ADDENDUM NO. 2

American River College New Temporaries Project

LRCCD BID NO. 17027

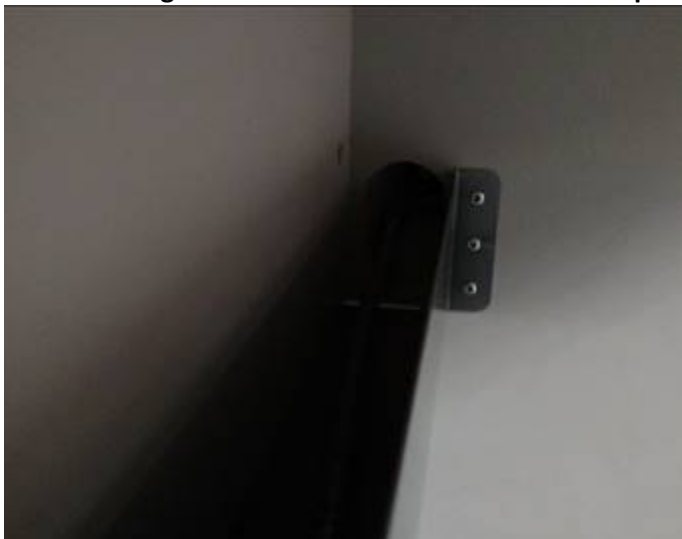
RFI #5: Sheet A3.1 consider timely doors and frames for this work, 3 week lead time for these doors and frames, and we do not have to wait till the HM frames are installed (usually 6 week lead time) to complete the finishes. Timely knock down doors and frames are pre-finished, and they exactly what is inside the new computer labs we saw on the site visit.

RESPONSE #5: It is acceptable to use timely knock down doors and frames.

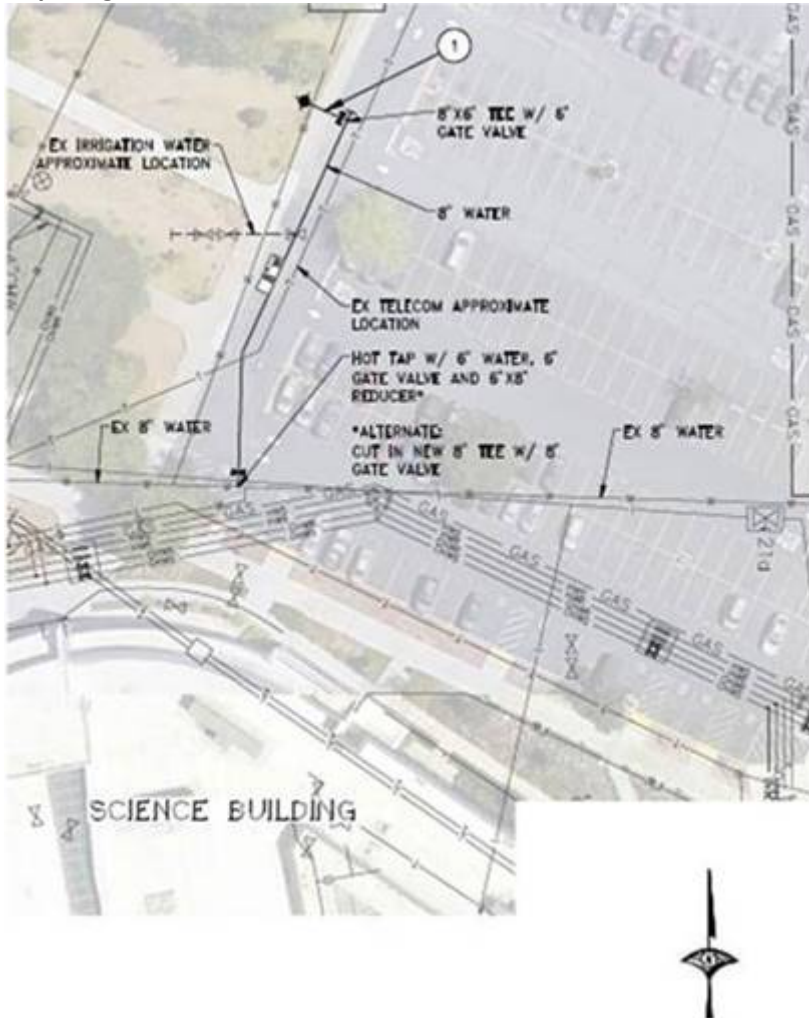
RFI #2: Page C 2 showing the fire water is unusable. It does not show "POC" point of connection and in relationship on where the new line is going in relation to the site plan. This information should be clearly shown the civil site plan, which will give us information as to how it relates to the whole site.

RFI #7: Plan C2.0 Fire hydrant plan is Hard to Read and Understand where the point of Connection is in relation to the Buildings per the Site plan. Can you show the point of the Hot Tap Connection to the New Hydrant Spot On the Site A1.1 or Grading plans C2? Will there be concrete or ac Patch Required?

RESPONSE #2: Please refer to sheet C2.0 detail, shown below.

RESPONSE #7: Please refer to sheet C2.0 detail, shown below, for point of connection and surfaces requiring restoration.
